## WIDTV1 Silkscreen & Labels

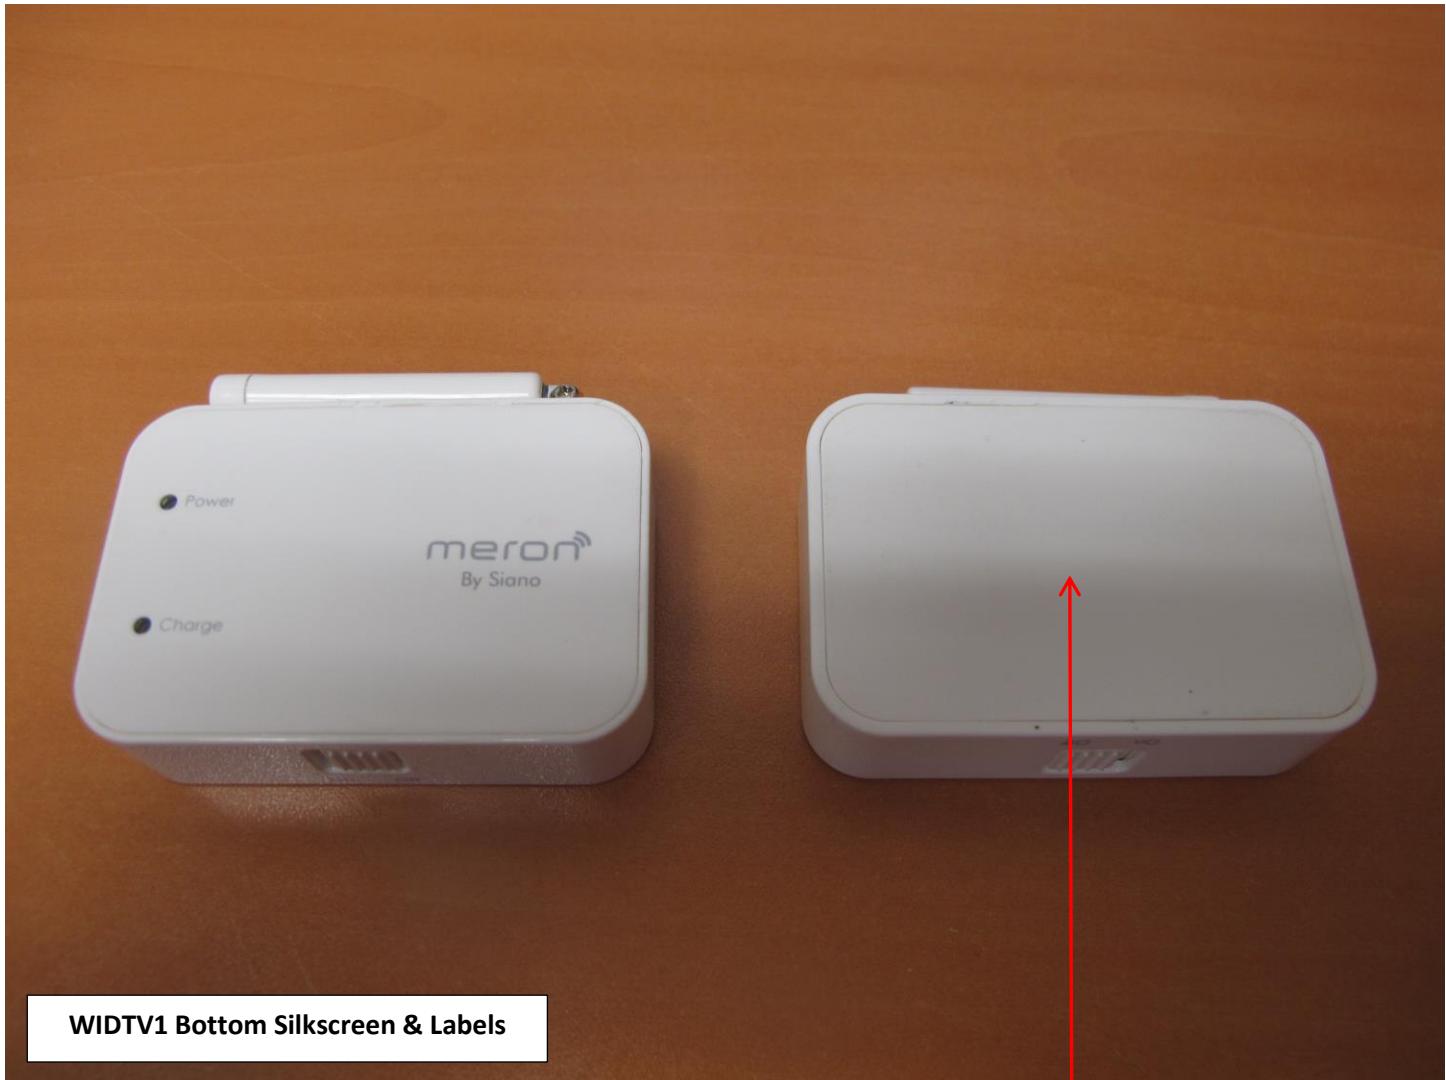
The above photo shows the WIDTV1 module with the new “audiovox mobiletv” logo. The logo is attached to the original e-mail and contained within a zip file. The size of the logo is approximately 85% of the size of the actual logo, the rough dimensions are 8.2mm high by 18.76 wide. The width dimension does not include the registered logo, ®.

The new logo shall be placed in the same location as the “meron by Siano” logo.

Please confirm that the information on the bottom of the label shown on the right (e.g. FCC Info, Audiovox Logo, Model #, etc.) will be silkscreened on the Bottom Panel of the WIDTV1 device. Also confirm that the Audiovox 18-digit Serial Number Label and MAC Address will be applied to the bottom of the WIDTV1 via a label.
